P 29881

SEWAGE DISPOSAL SYSTEM

MARYLAND STATE DEPARTMENT OF HEALTH*

ROAD 3698 Shady Lane

PERMIT CARD

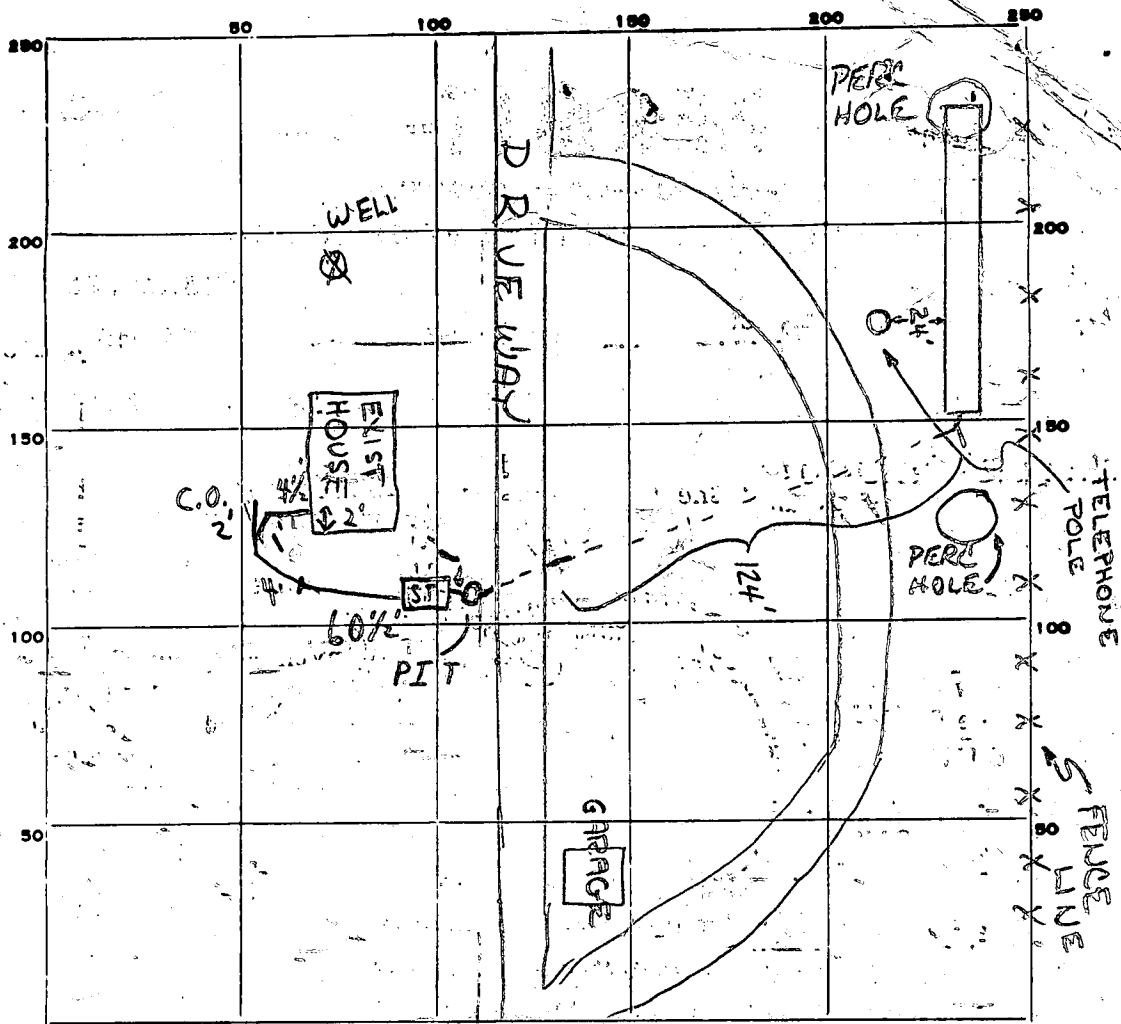
REPAIR-CALL FOR INSPECTION WHEN GROUND IS OPENED UP SO SANITARIAN CAN RECOMMEND

REPAIR SYSTEM. 12/4/79 DEEP DITCH 10 1/2 FT DEEP 2 FT

WIDE 7 FT STONE (460 SQ FT) 66 FT LONG

PLACE DITCH 15 FT FROM THE FENCE IN FRONT OF THE HOUSE

PARALLEL TO THE FENCE

SEWAGE LIFT PUMP NEEDED HERE

REMARKS 12/6/79 - OK TO ADD GRAVEL TO TRENCH. CHECK TO SEE IF 2" PLASTIC PIPE IS OK TO RUN UNDER DRIVEWAY AT 2'-3' R.D. - PLASTIC PIPE MUST BE ENCASED, CALLED INSTALLER LEFT MESSAGE TO ENCASE IT. 12/6/79

12/7/79 TRENCH OK TO COVER TO 3' OF AREA OF CONNECTION. FROM 4:10 PM P.M.

SEPTIC TANK AREA - OK TO COVER LINE* TO 1' OF PIT; OK TO COVER FROM SAND TO 1' OF EITHER END OF C.I. PIPE UNDER DRIVEWAY'S HOUSE TO THE SEPTIC TANK AND TO PIT. CALLED OK TO COVER LINE EXCEPT FOR ABOVE AREAS NOTED. DISCUSSED WITH MR WINE VIA MR CONDON'S PHONE IN

TRUCK. P.M. TO CALL FOR FINAL. C.B.D. 12/10/79 OK to cover all work
